# FY 2025-26 Standard Plans Update Training

Rick Jenkins, P.E  
State Standard Plans Engineer  
Roadway Design Office  
[Rick.Jenkins@dot.state.fl.us](mailto:Rick.Jenkins@dot.state.fl.us)

## STANDARD PLANS FY 2025-26 REVISIONS LOG

## Standard Plans Instructions (SPI) Part F. Variable Section Width Segments: Reduced Shoulder Widths...

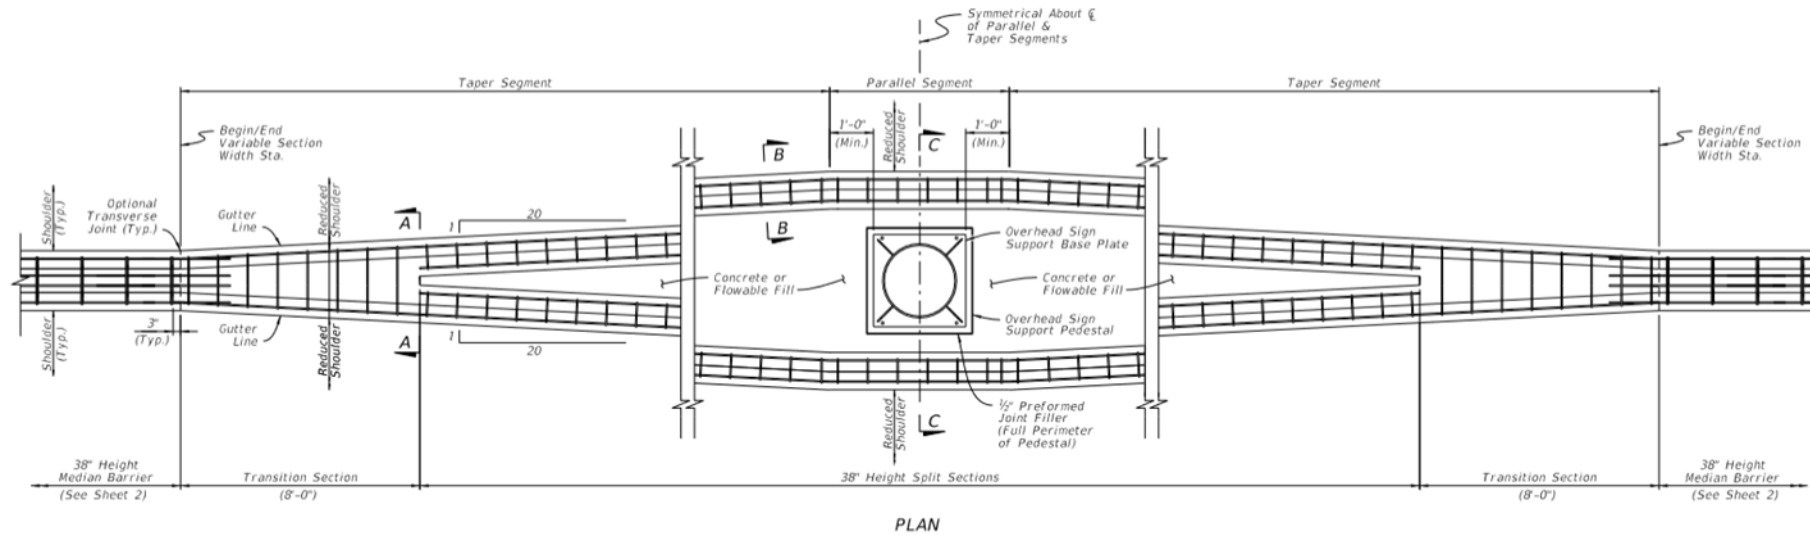
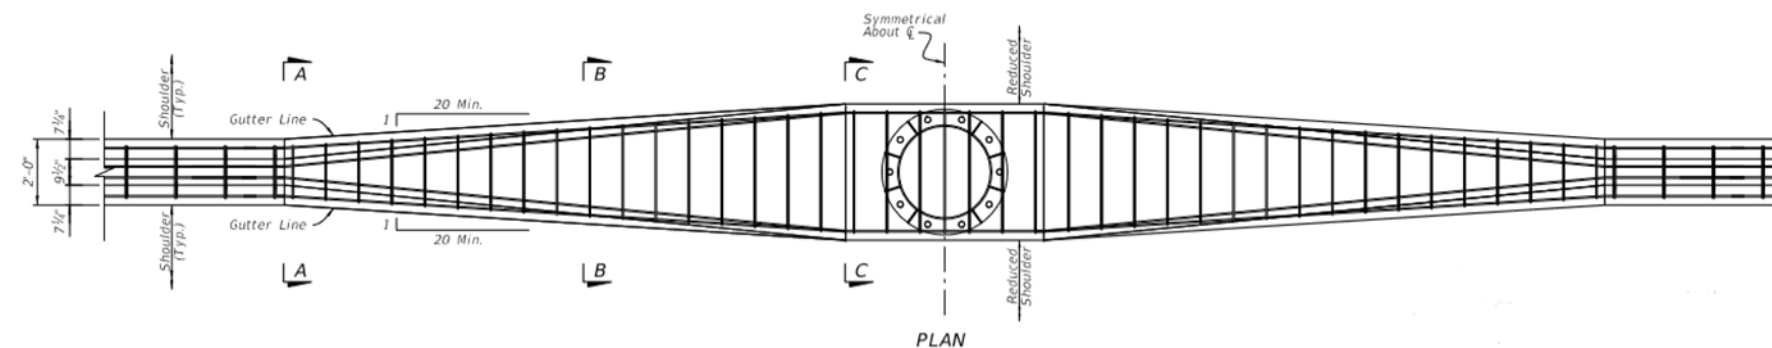
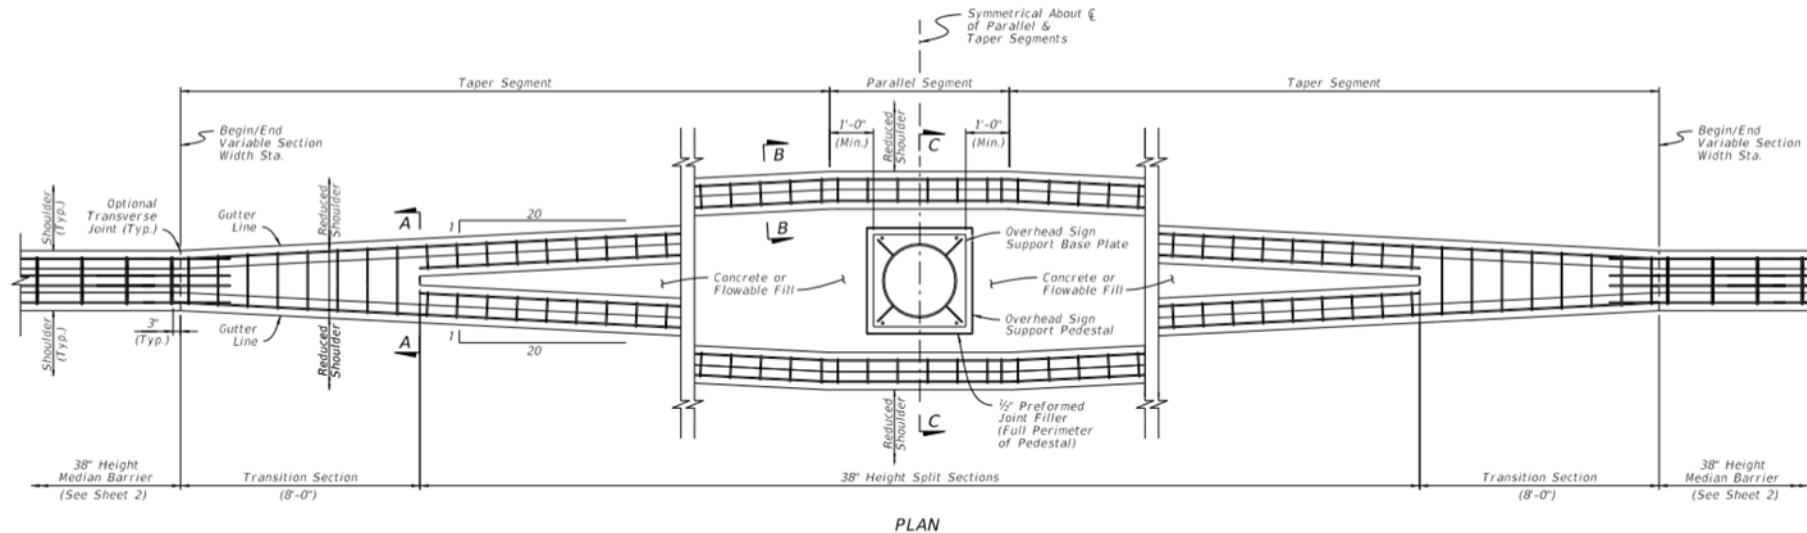
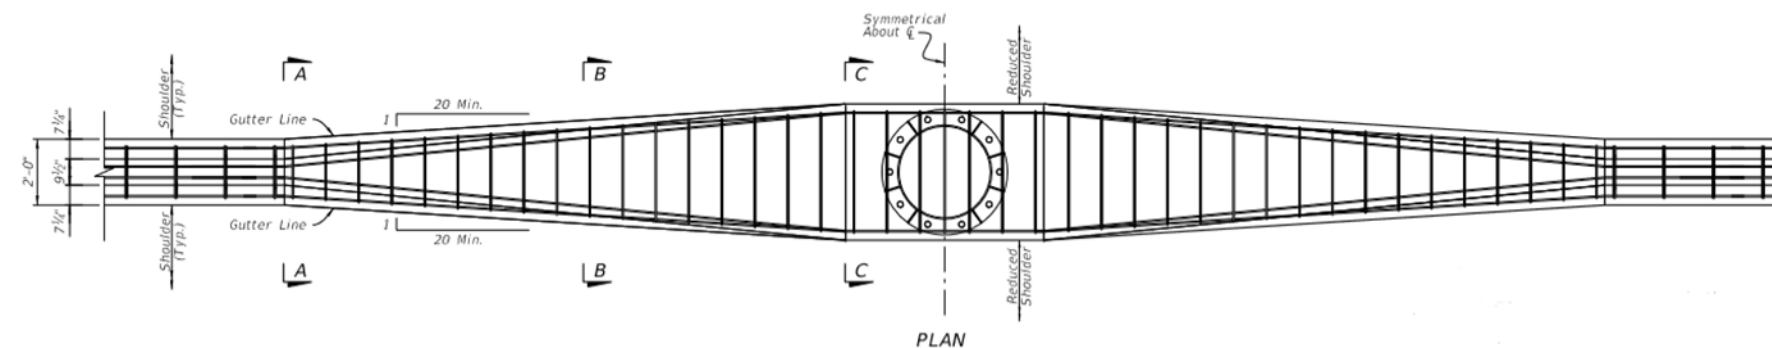
- **New Guidance provided to address reduced shoulder widths:**
- Project-specific evaluation is needed for reduced shoulder widths:
  - Consider “Emergency Shoulder Use” (ESU) needs per **FDM 211**
  - Consider general “Useable Shoulder Width” needs
  - Coordinate with District Design Office
  - **Reduced shoulder usage generally requires Design Exception per **FDM 122****

## Sheet 27 & 28: Guardrail Transition Connections (Approach and trailing)

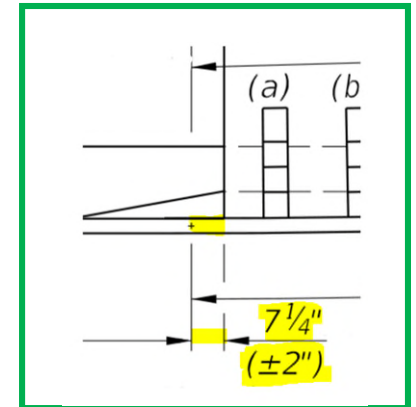
- Tolerance added for distance between end of concrete barrier and center of guardrail splice. Result:
  - Entire guardrail system has longitudinal tolerance of ( $\pm 2''$ )

## All-New Sheet 4: Spread Footing Foundation Option

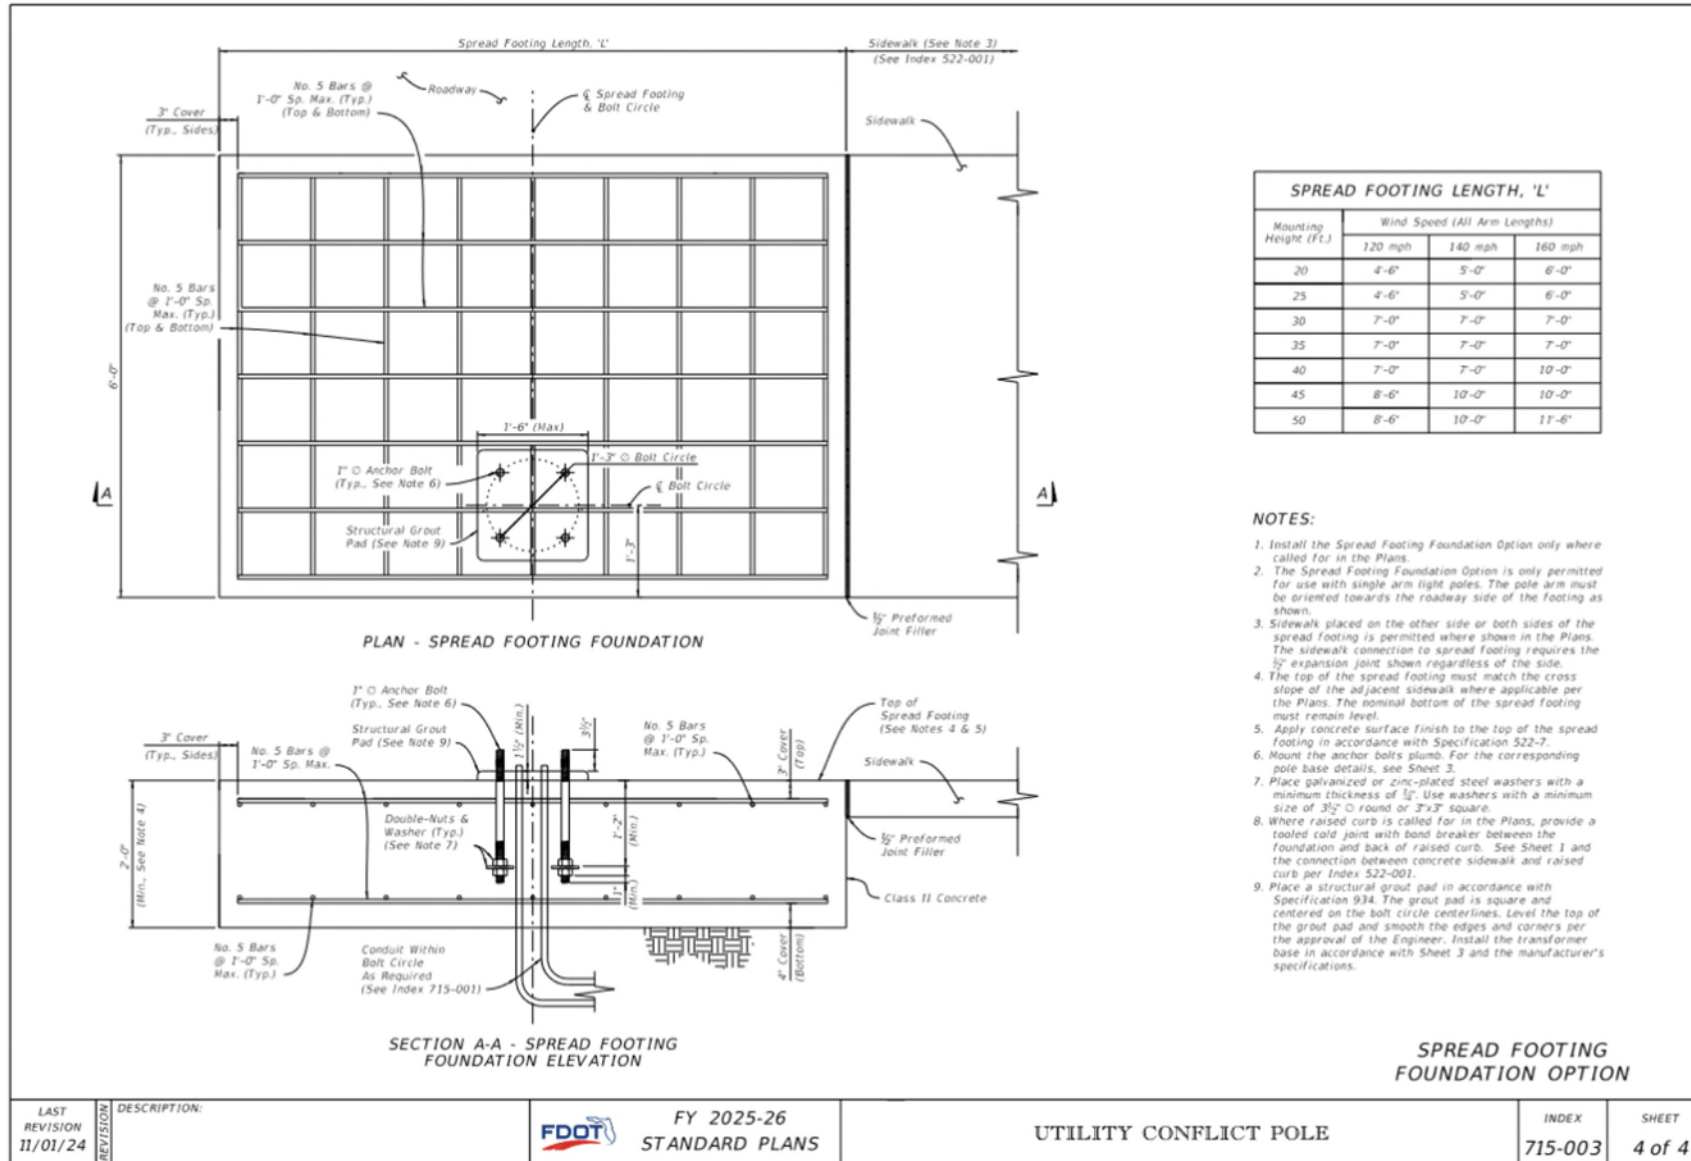
- **Added Spread Footing Foundation Option...**
  - Saves space in constrained conditions (typically urban)
  - Avoids underground utility conflicts
  - Doubles as a sidewalk surface
  - Designed to meet **FDM 222** clearance needs for pedestrians
- Light pole orients towards roadway

## Sheet 6:

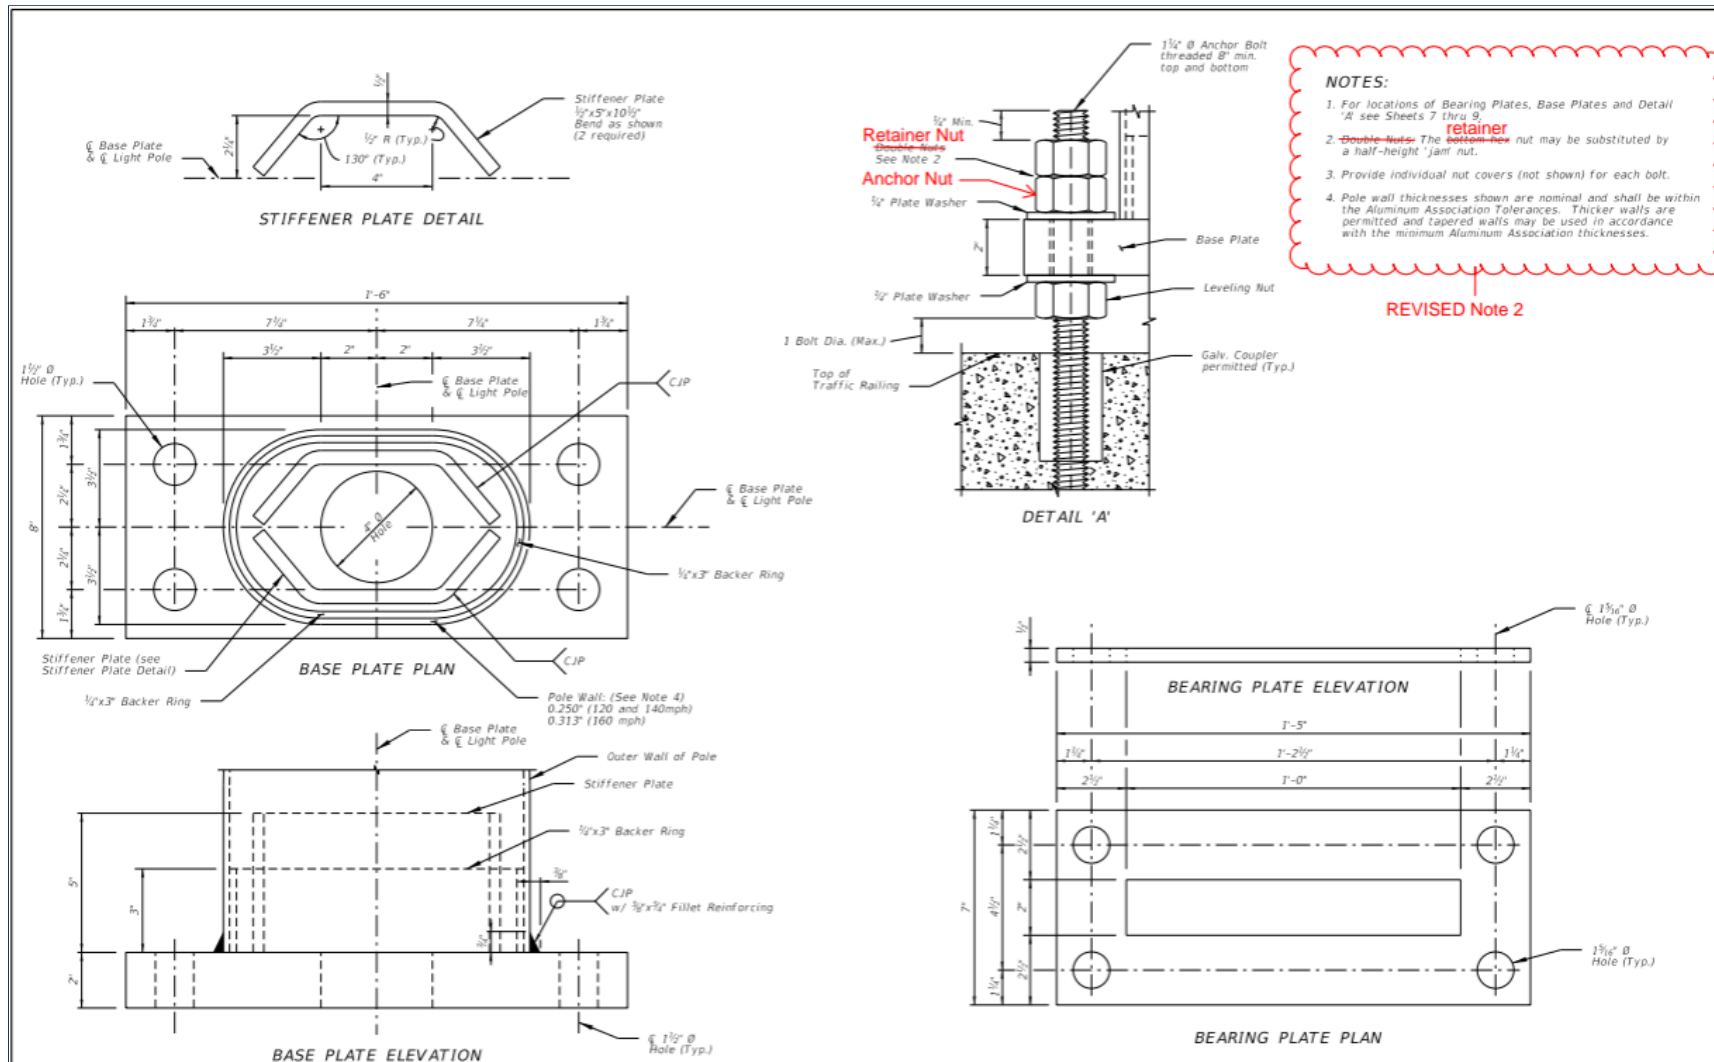
- *Sheet 6: Updated anchor bolt labels in Detail A; Updated Note 2 language and corrected which nut may be half height.*

REVISED Note 2
